E R R A T A

NACA TN No 1655

THERMODYNAMIC CHARTS FOR THE COMPUTATION OF FUEL QUANTITY
REQUIRED FOR CONSTANT-PRESSURE COMBUSTION WITH DILUENTS

By Donald Bogart, David Okrent, and L Richard Turner
July 1948

Figure 6 - Fuel-air ratio increment Δf for addition to fuel-air mixture of water-alcohol mixtures containing more than 75-percent water by weight $\Delta f = K_m K_h (f'' + \delta_2 f'' + \delta_3 f'' + \delta_h f'')$

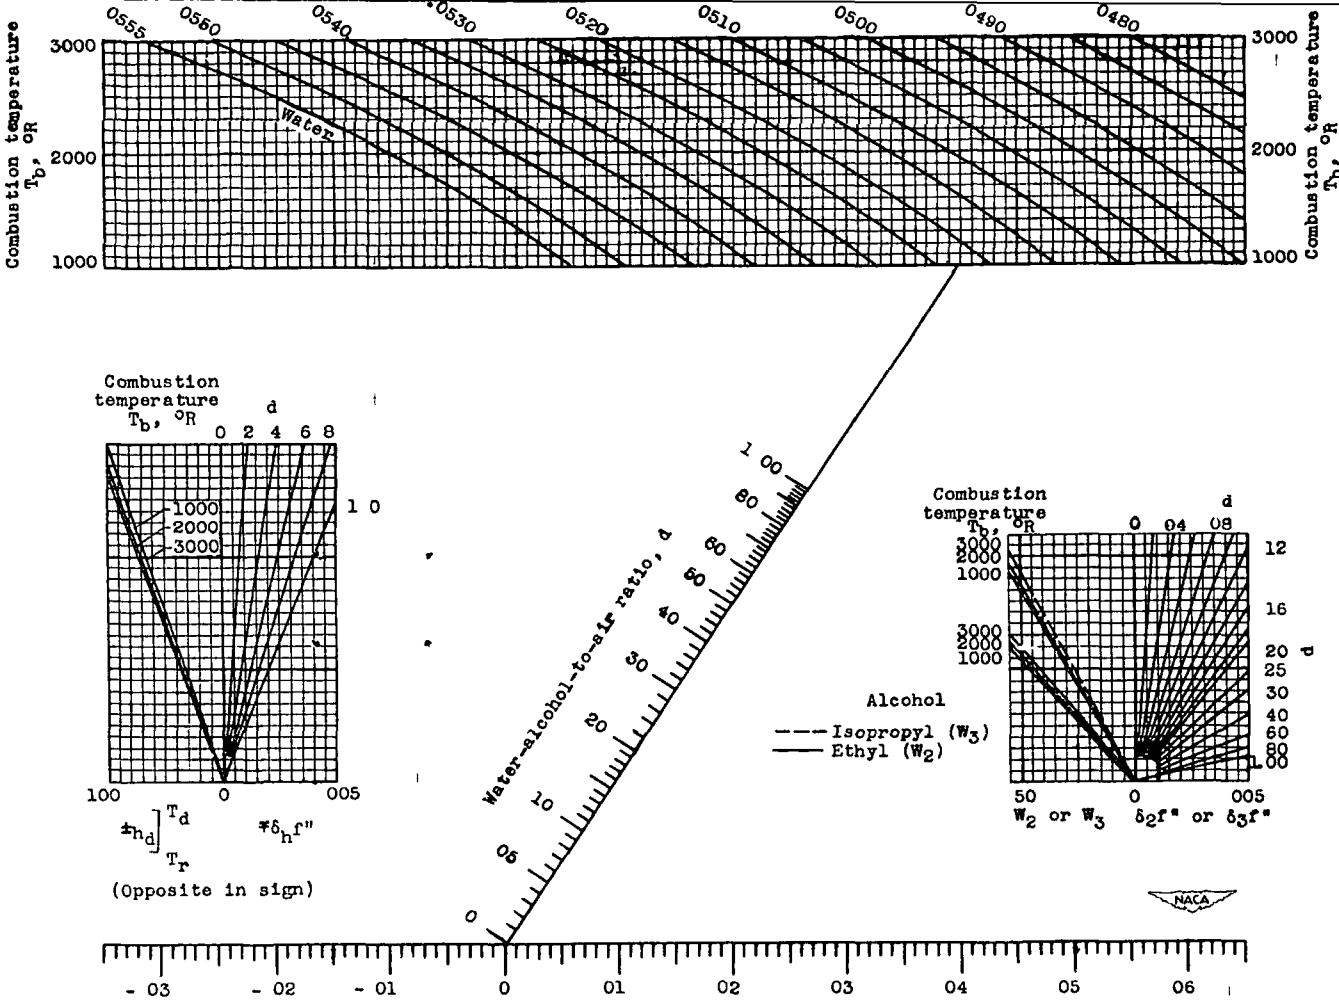
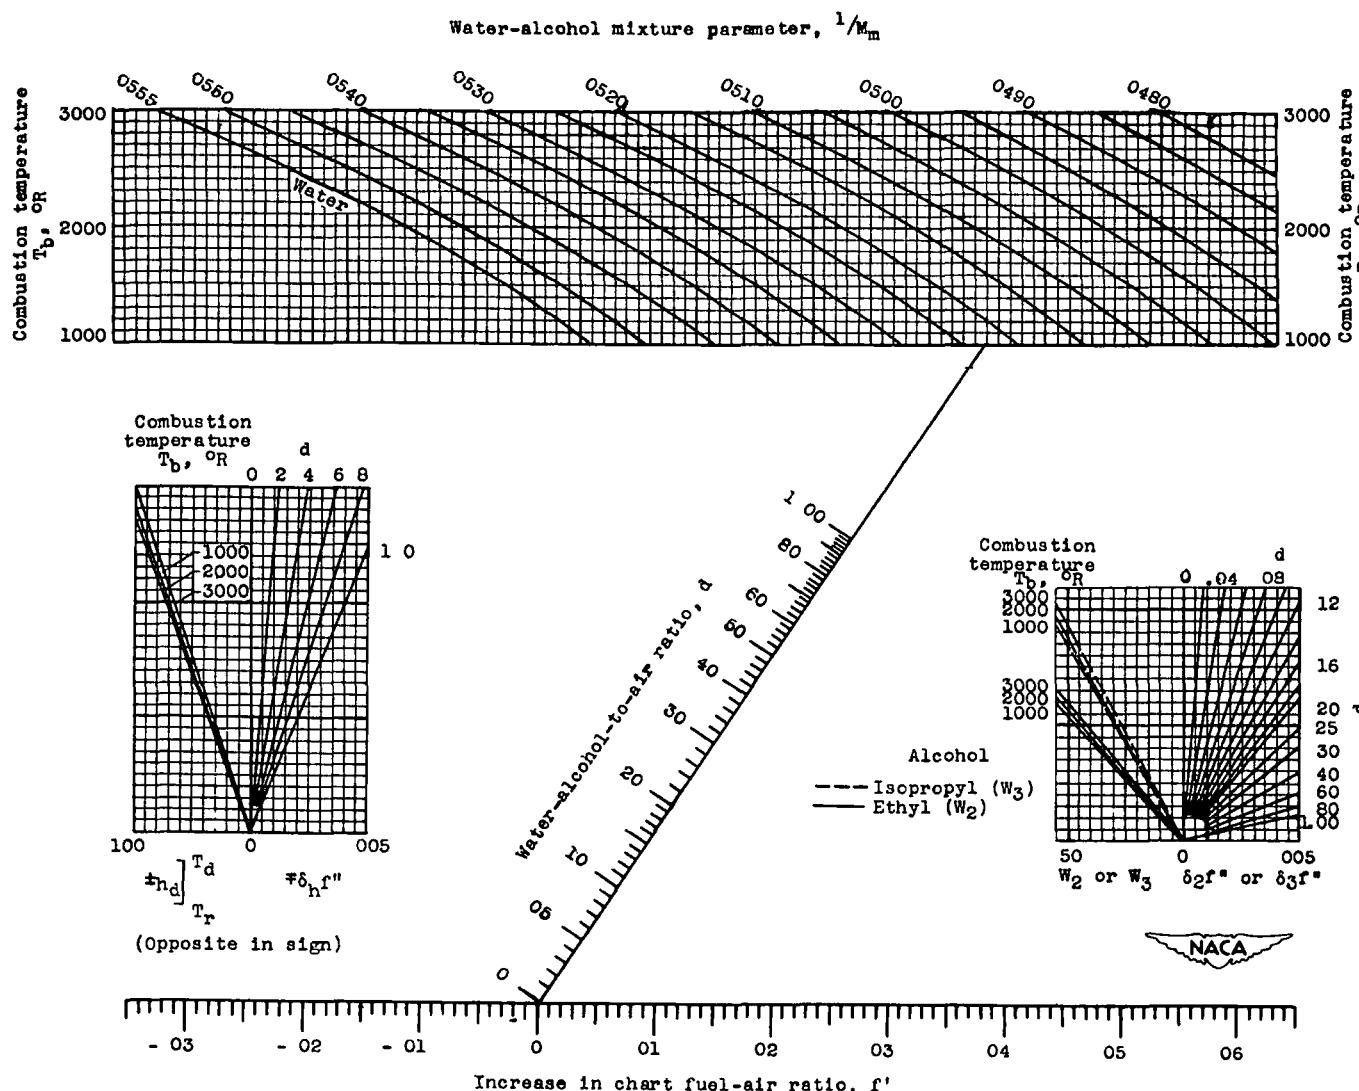
The page-size version of figure 6 was incorrectly prepared for reproduction, the corresponding large-size chart enclosed in the back of the report was, however, prepared correctly

Figure 13. - Fuel-air-ratio increment Δf for addition of liquid oxygen to fuel-air mixture $\Delta f = K_m K_h f''$.

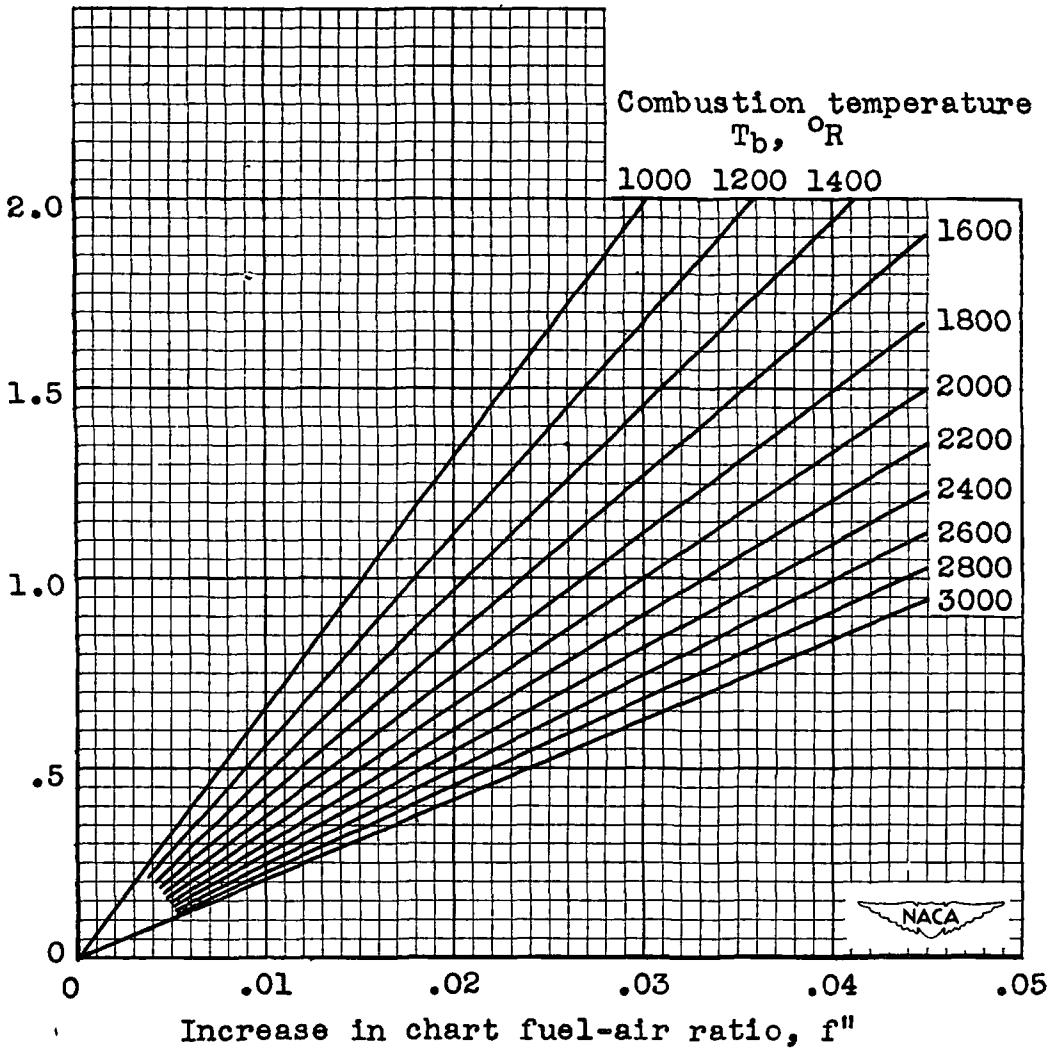
The ordinate label of figure 13 was incorrectly listed nitrogen-air ratio instead of oxygen-air ratio
